Amendments to the Drawings:

Application Serial No. 10/711,331
Annotated Sheet Showing Changes

Fig. 1
(PRIOR ART)

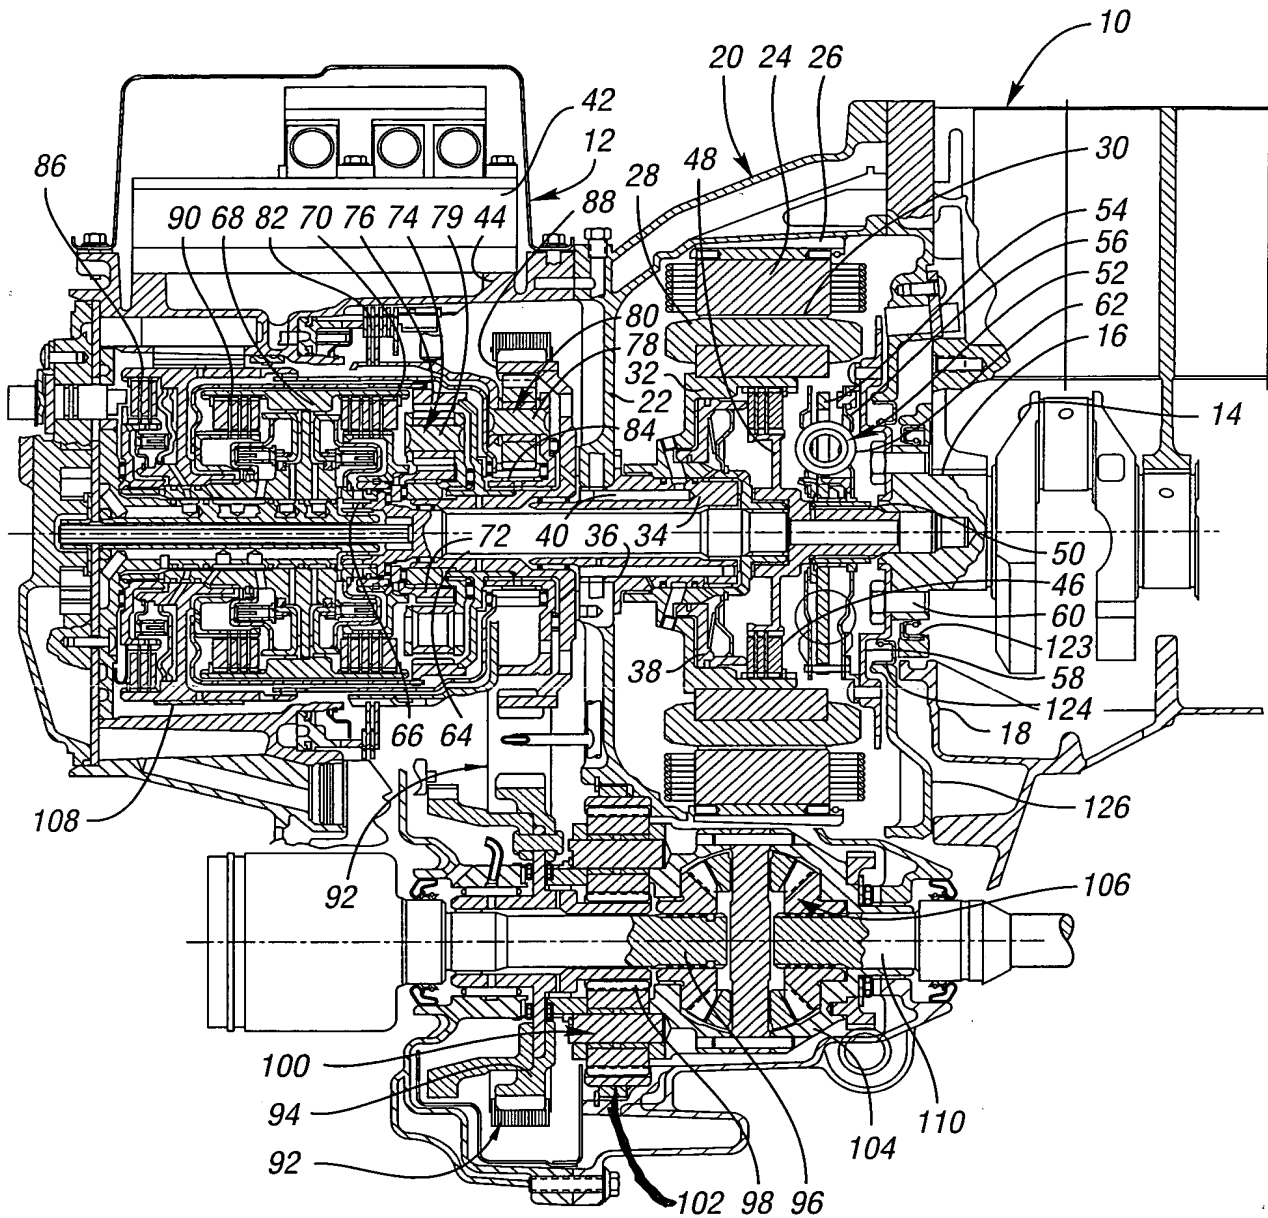
Figures 1, 7a and 7c are amended as shown by red check marks on the attached marked-up copy of these figures. The change to Figure 1 makes the lead line or numeral 102 shorter. The change to Figure 7a relocates numeral 182 so that it identifies a short initialization time. The change to Figure 7c extends the arrowhead for the lead line for the measured 2-4 pressure so that it touches plot 202.
